Tiffin Regular City Council Meeting
Tiffin Regular City Council Meeting
September 01, 2026 07:00 pm

DATE:	August 27, 2026
AGENDA ITEM:	Approval of Change Order #3 – Tricon Construction Group – Water Treatment Facility Upgrade
ACTION:	Motion

CHANGE ORDER NO.: 3

Owner:	City of Tiffin	Owner's Project No.:	
Engineer:	MSA Professional Services	Engineer's Project No.:	13603021
Contractor:	Tricon Construction Group	Contractor's Project No.:	25-012-IA
Project:	Tiffin WTF Upgrade		
Contract Name:	13603021 – Tiffin WTF Upgrade		
Date Issued:	August 19, 2026	Effective Date of Change Order:	September 1, 2026

RO BUILDING

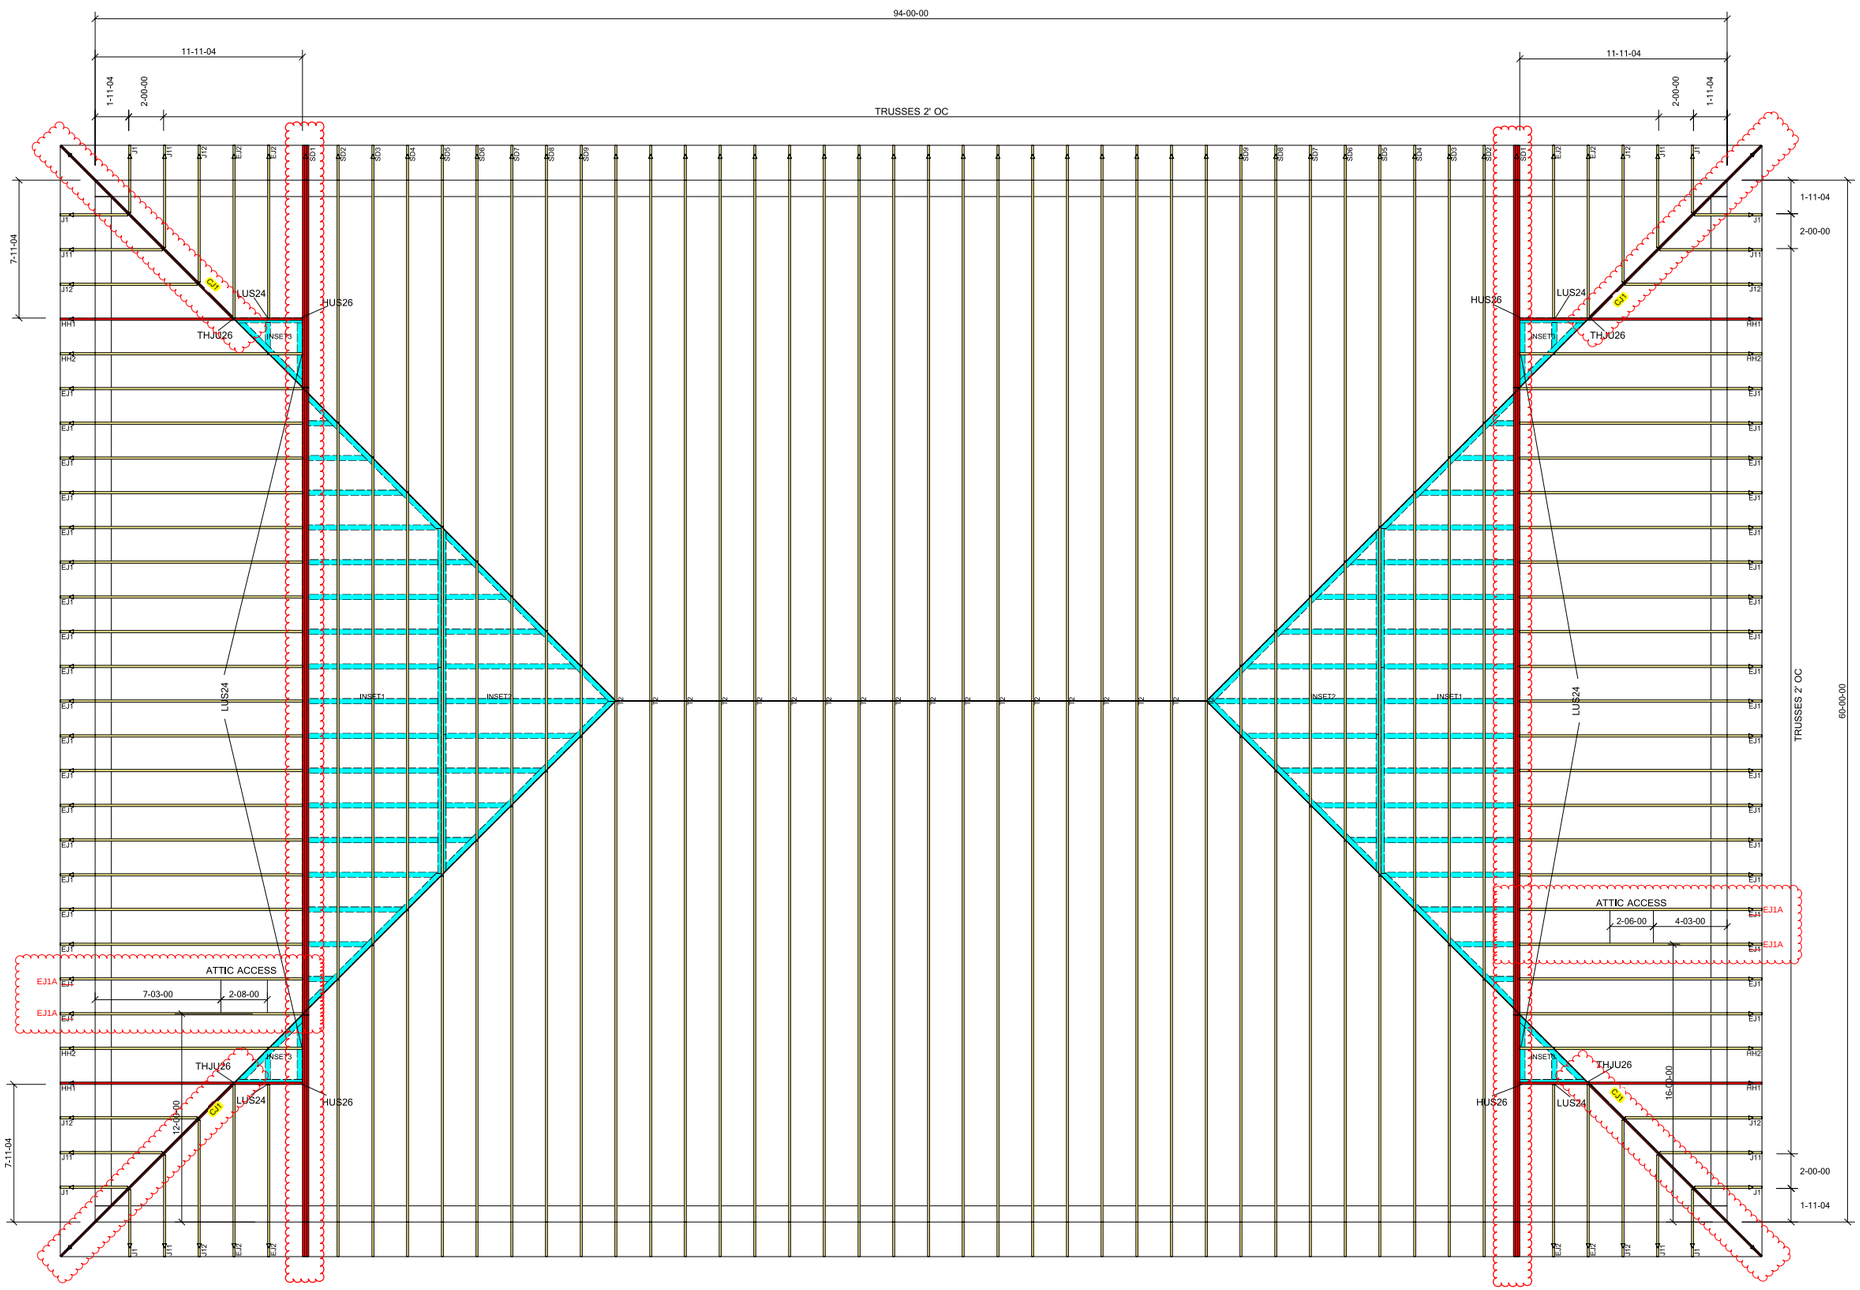
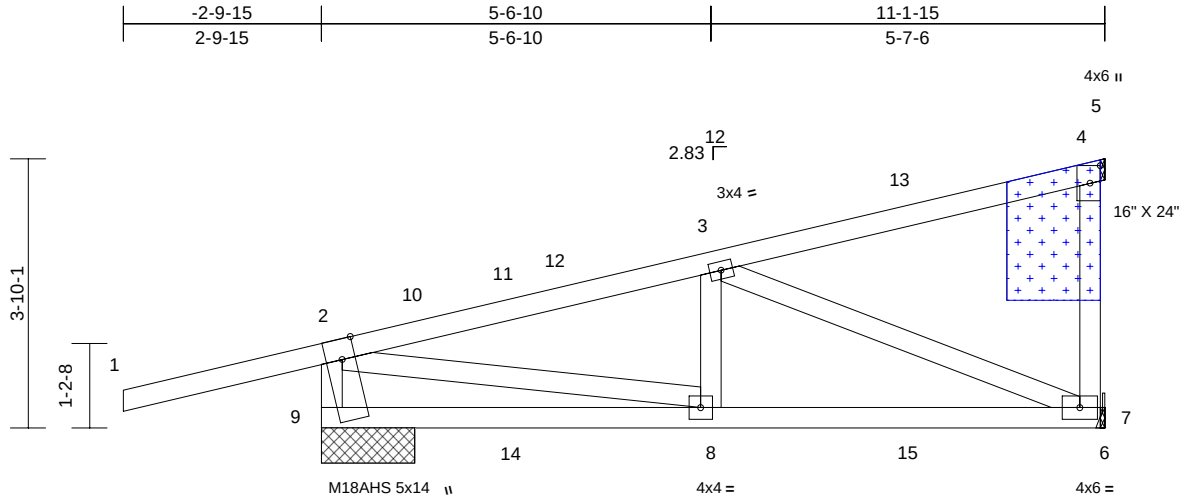
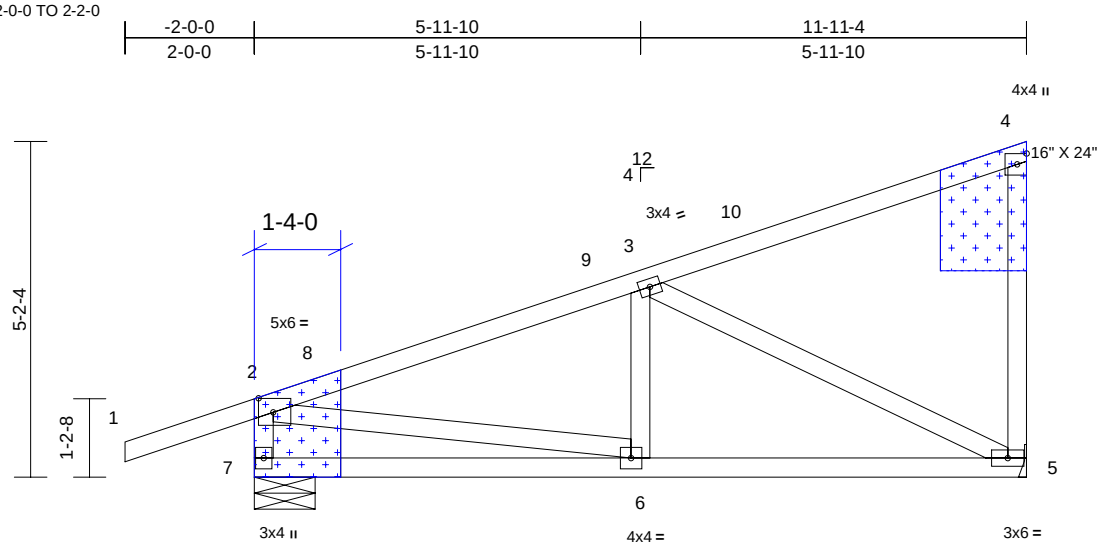
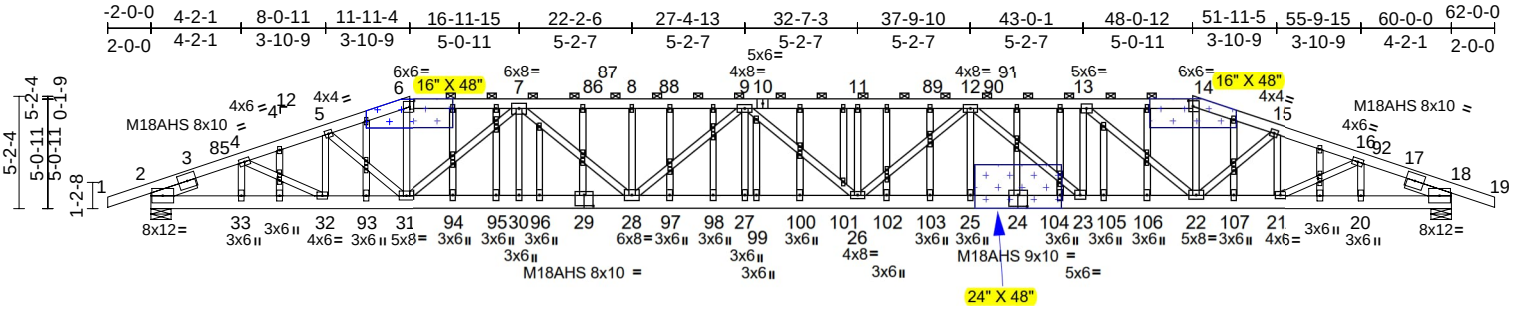
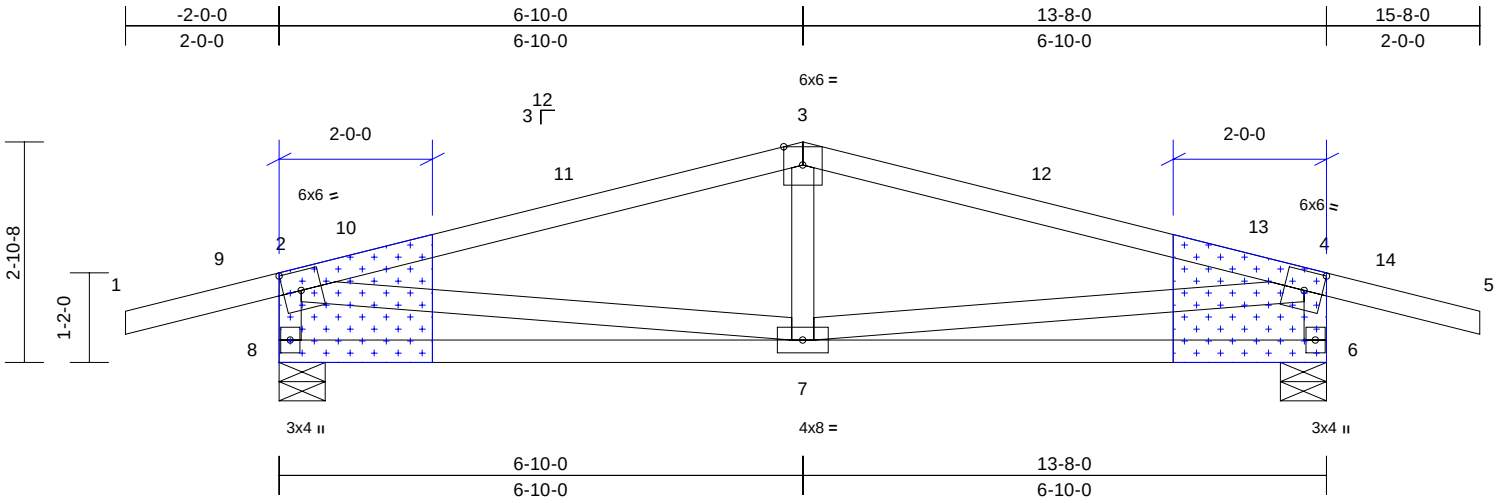
Required truss modifications due to code changes indicated here

REPAIR:
BUILDING CODE CHANGED FROM 2015 TO 2018

REPAIR:
BUILDING CODE CHANGED FROM 2015 TO 2018
SPACING CHANGED FROM 2-0-0 TO 2-2-0

REPAIR:
BUILDING CODE CHANGED FROM 2015 TO 2018

ATTACH 1/2" PLYWOOD OR OSB GUSSET (15/32" RATED SHEATHING 32/16 EXP 1) TO EACH FACE OF TRUSS WITH (0.131" X 2.5" MIN.) NAILS PER THE FOLLOWING NAIL SCHEDULE: 2 X 4'S - 3 ROWS: SPACED @ 4" O.C. NAILS TO BE DRIVEN FROM BOTH FACES. STAGGER SPACING FROM FRONT TO BACK FACE FOR A NET 2" O.C. SPACING IN EACH COVERED TRUSS MEMBER. USE 2" MEMBER END DISTANCE.

ATTACH 1/2" PLYWOOD OR OSB GUSSET (15/32" RATED SHEATHING 32/16 EXP 1) TO EACH FACE OF TRUSS WITH (0.131" X 2.5" MIN.) NAILS PER THE FOLLOWING NAIL SCHEDULE: 2 X 4'S - 3 ROWS: SPACED @ 4" O.C. NAILS TO BE DRIVEN FROM BOTH FACES. STAGGER SPACING FROM FRONT TO BACK FACE FOR A NET 2" O.C. SPACING IN EACH COVERED TRUSS MEMBER. USE 2" MEMBER END DISTANCE.

ATTACH 3/4" PLYWOOD OR OSB GUSSET (23/32" RATED SHEATHING 48/24 EXP 1) TO EACH FACE OF TRUSS WITH (0.131" X 2.5" MIN.) NAILS PER THE FOLLOWING NAIL SCHEDULE: 2 X 4'S - 3 ROWS, 2 X 6'S AND LARGER - 4 ROWS: SPACED @ 4" O.C. NAILS TO BE DRIVEN FROM BOTH FACES. STAGGER SPACING FROM FRONT TO BACK FACE FOR A NET 2" O.C. SPACING IN EACH COVERED TRUSS MEMBER. USE 2" MEMBER END DISTANCE.
